**EGG-SSRE-9926
November 12, 1991**

**EVALUATION OF EPRI DRAFT
REPORT NP-7065 - REVIEW
OF NRC/INEL GATE VALVE
TEST PROGRAM**

**Prepared for the
U.S. NUCLEAR REGULATORY COMMISSION**

**Robert Steele, Jr.
John C. Watkins
Kevin G. DeWall**

Figure 17. Selected upstream pressures for Valve 2 during Step 25 of Test 1.

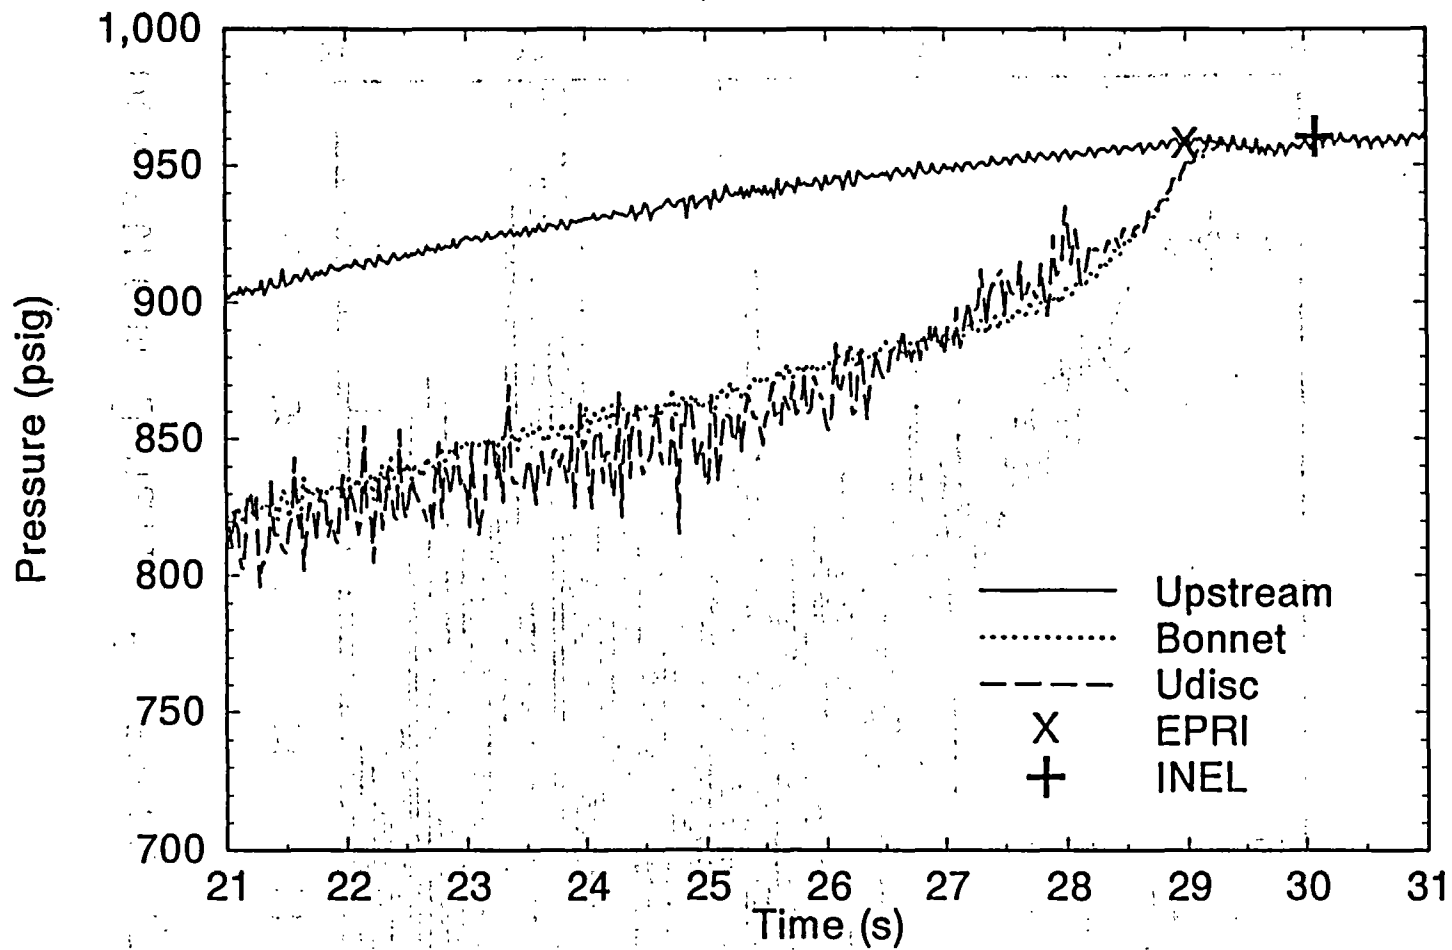
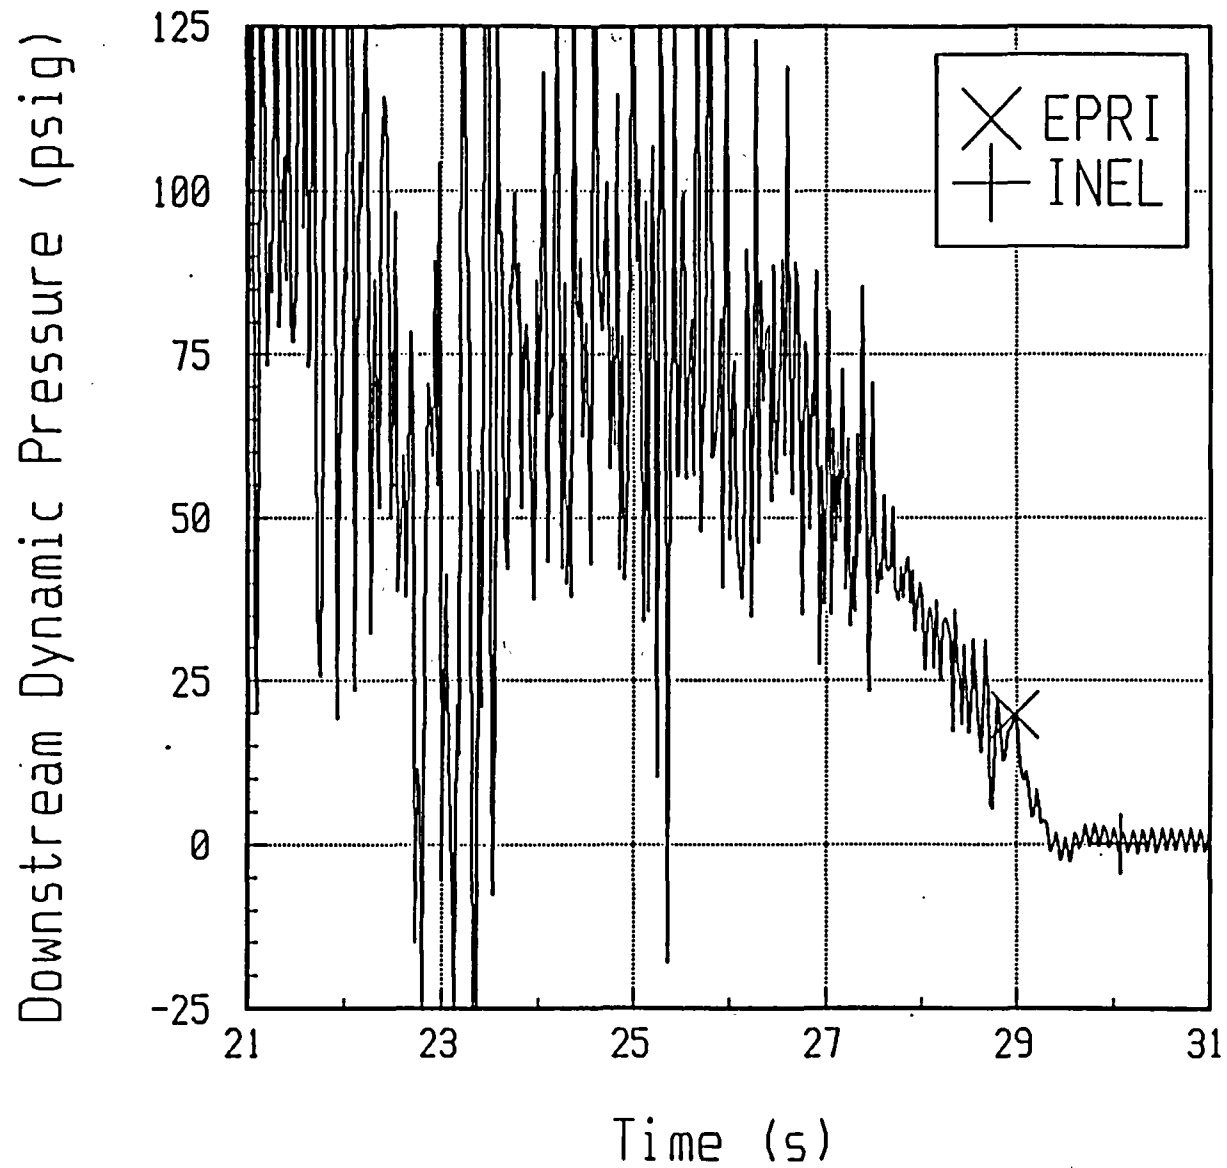
By way of example, Figures 16 through 18 show the stem force, the upstream, bonnet, and under-the-disc pressure, and the downstream dynamic pressure histories for Valve 2 Test 1 Step 25. Also shown on each of these figures is the point identified as flow isolation as shown on Table 6-1 of the EPRI report and the point used by the INEL to assess the response of the valve.

Figure 19. Disc factor for Valve 2 closing on line break flow, effect of subcooling at 1000 psig.

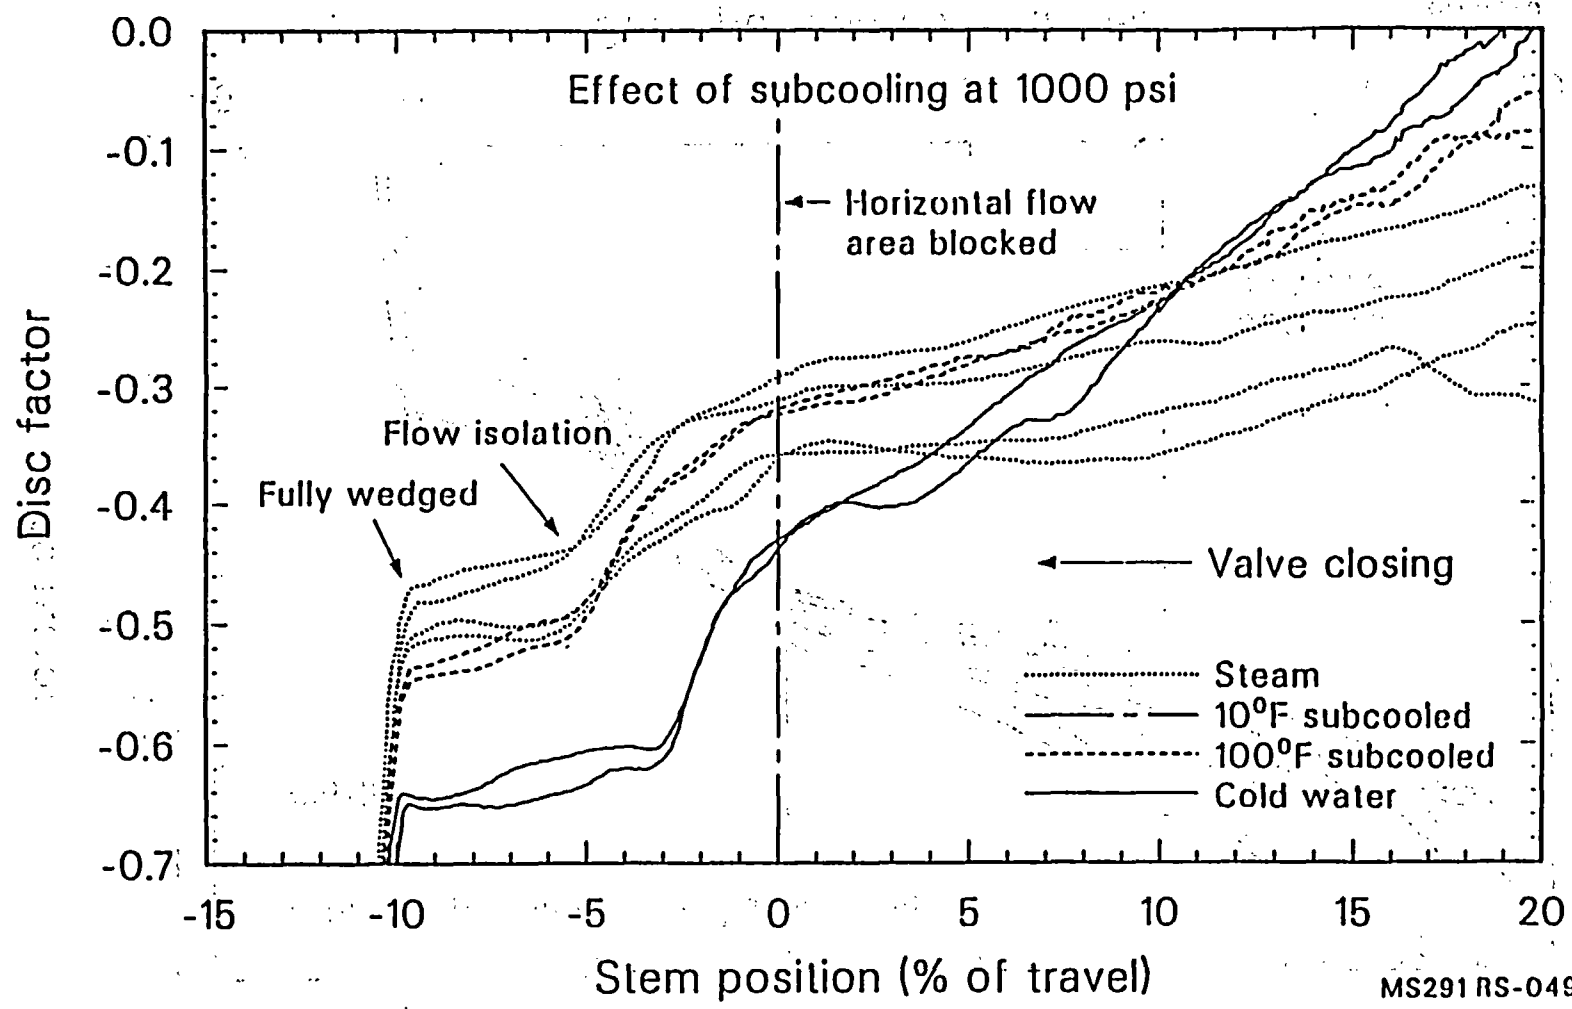
Figure 19 shows disc factor data for Valve 2 closing against four different fluid conditions, steam to cold water. In this particular figure, we used the valve orifice area for the disc area term as it represents the least conservative use of this term by the industry. For predictable valves, the plateau between isolation and wedging represents the highest stem force in the closing stroke prior to wedging. We selected the mid point of the plateau as being indicative of the stem force required to isolate flow through a valve. Figure 19 clearly shows that the disc factor varies with the degree of subcooling, with steam conditions producing the lowest disc factor and cold water producing the highest.

Figure 20. Disc factor for Valve 2 closing on line break flow, effect of pressure at 100°F subcooling.

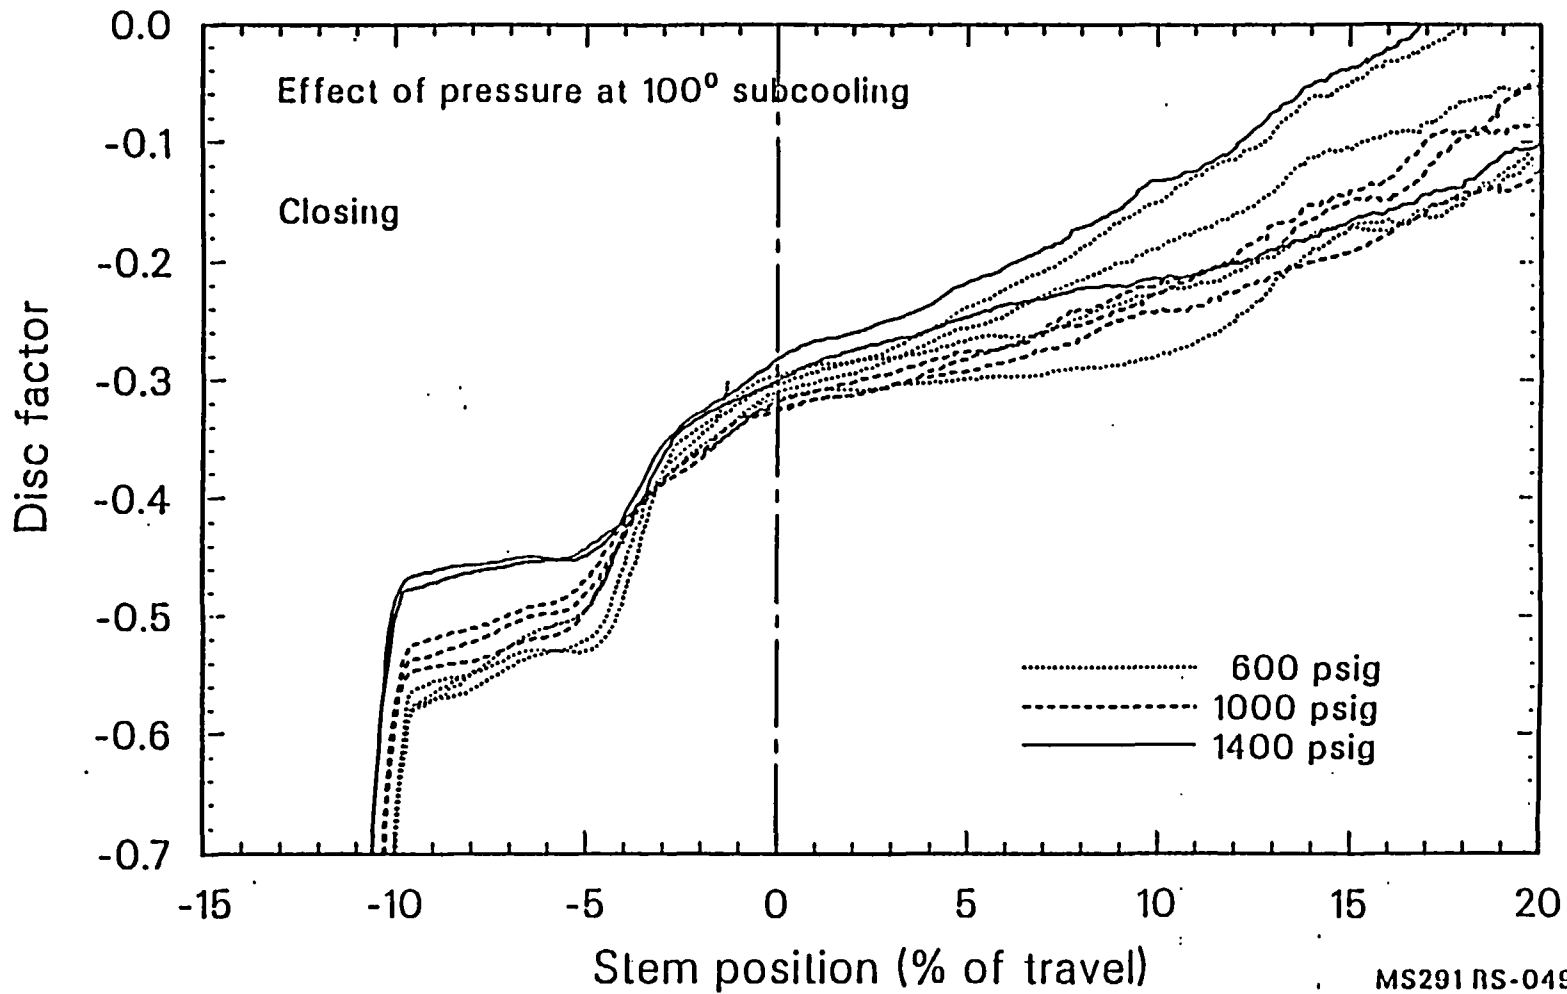
Figure 20 shows disc factor data for Valve 2 closing against three different pressures with the same degree of subcooling. A pattern in the data scatter is evident. Surprisingly, the disc factor is higher with lower pressures, and lower with higher pressures.

These results were unexpected, and the subsequent analysis performed by the INEL, as described in more detail in Appendix C, defined the force balance on the disc and a new correlation for assessing valve performance. During the development of the correlation, we discovered that the standard industry equation does not account for the pressure effects and fluid condition effects described above, and does not account for valve design characteristics that are acted upon by the differential pressure. One of these effects is the result of the angle of the downstream seat, which lies approximately 5 degrees from vertical. Appendix C presents a complete discussion of these effects.

Figure 21. Stem force history of Valve A closing against 1000 psi, 10°F subcooled fluid at full flow conditions.

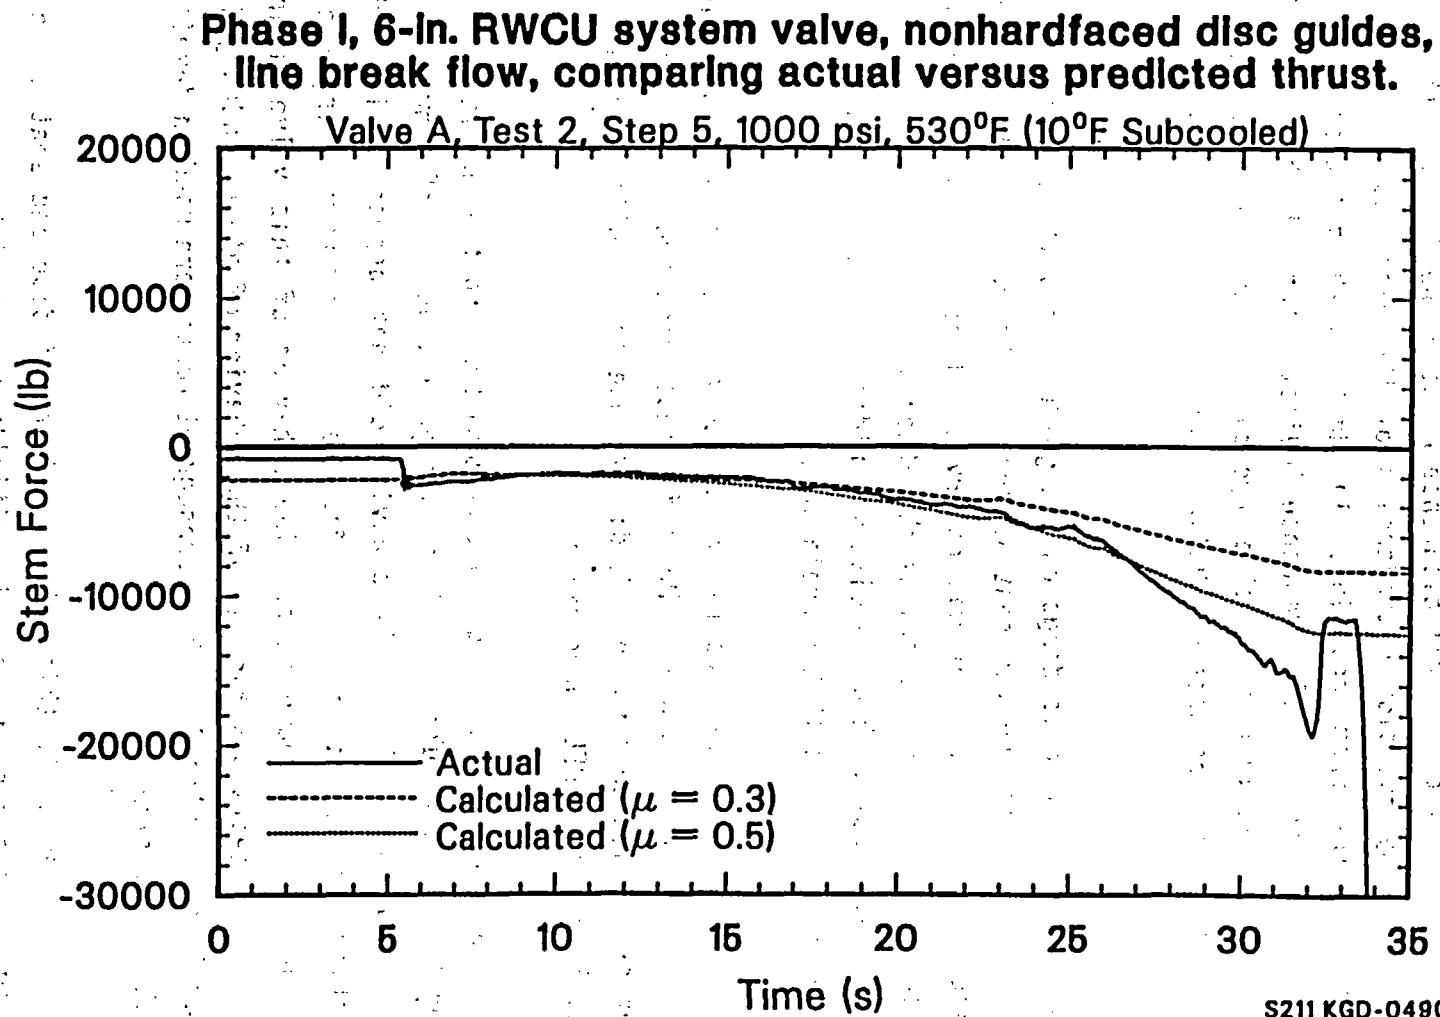
Valve A - This valve performed unpredictably during mid stroke, evidenced by damage to the disc and valve body guides. However, once the disc began riding on the valve body seats, the valve responded in a predictable manner (see Figure 21). We used selected Valve A test results in the

Figure 24. Pressure traces for Test 3 of Valve A, Phase I.

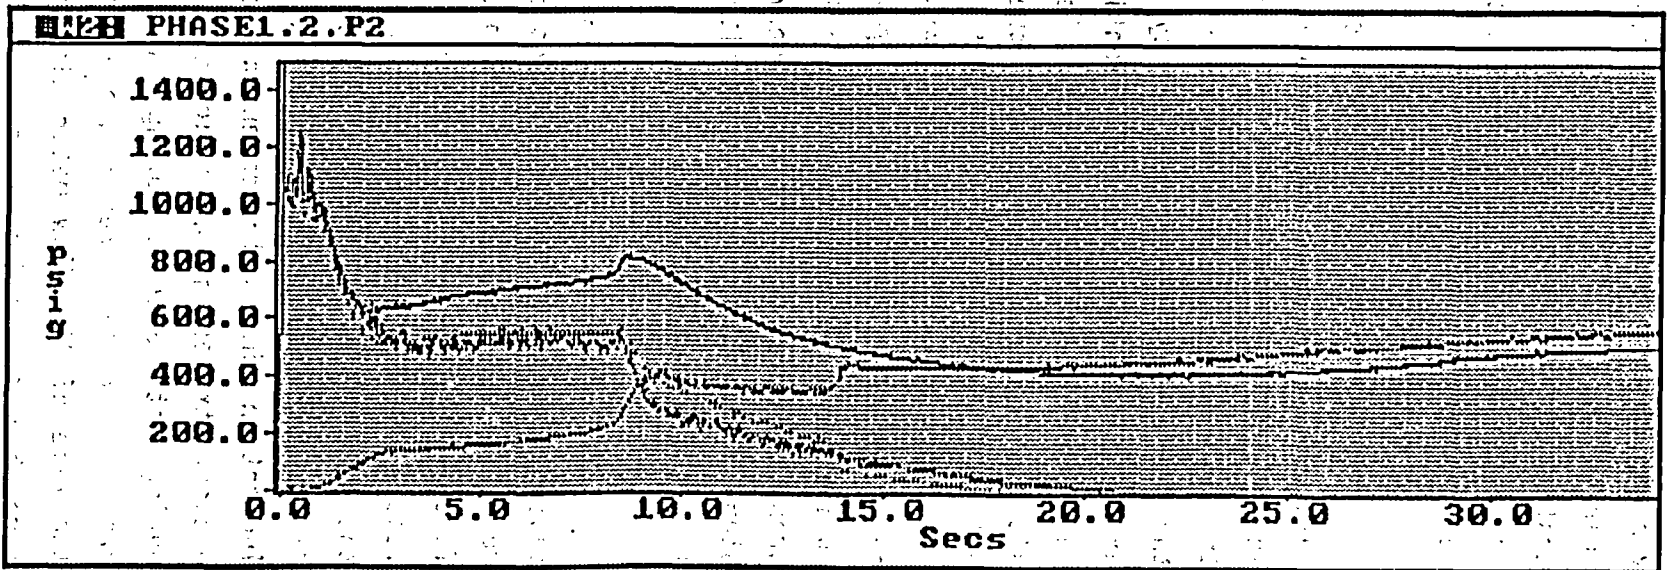
Our assessment of Phase I Test 3 Step 5 indicates that Valve A closed on a nitrogen/steam mixture for the last two thirds of the blowdown stroke. Figures 23 and 24 show pressure traces for this test. Figure 23 shows the

venturi flow meter differential pressure and, at 8 seconds, shows the disturbance pointed to in the EPRI report. Figure 24 shows that at this same time, the valve upstream static pressure increases, the valve differential pressure increases, the valve downstream static pressure decreases, and the exit pipe static pressure decreases.

Figure 25. Flow meter differential pressure trace for Test 2 of Valve A, Phase I.

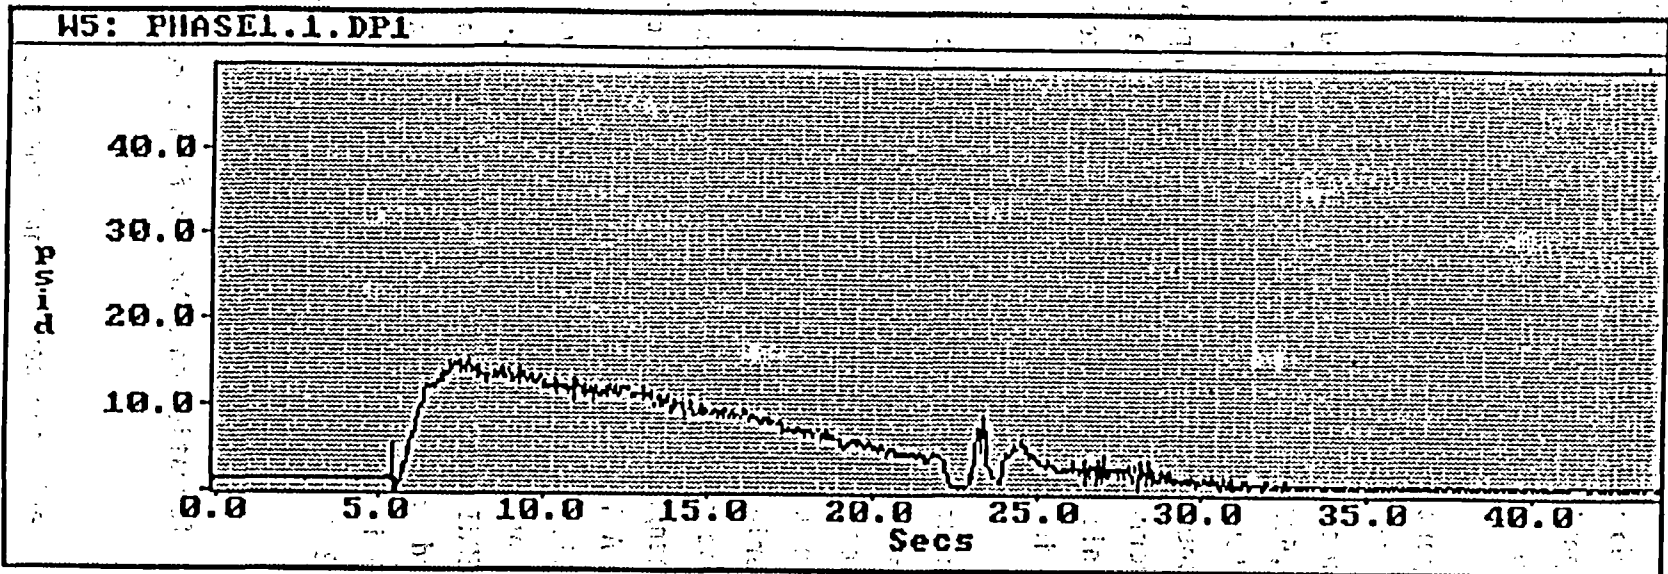
Fluid volume calculations also support this conclusion. During Test 2, the maximum flow (7,500 gpm) was measured at 15 psid (Figure 25), and the flow decreases somewhat linearly to zero 26 seconds later. The total consumed water inventory for Test 2 was approximately 1,625 gal, slightly less than half of the total accumulator inventory. The water level in the accumulator was over 8 feet at the end of the test. Flow rate was about 2000 gpm when the disruption pointed out in the EPRI report occurred. This corresponds to an in-tank fluid velocity of about 0.09 ft per second. It is unlikely that nitrogen would enter the discharge with the water over 8 ft deep in the tank.
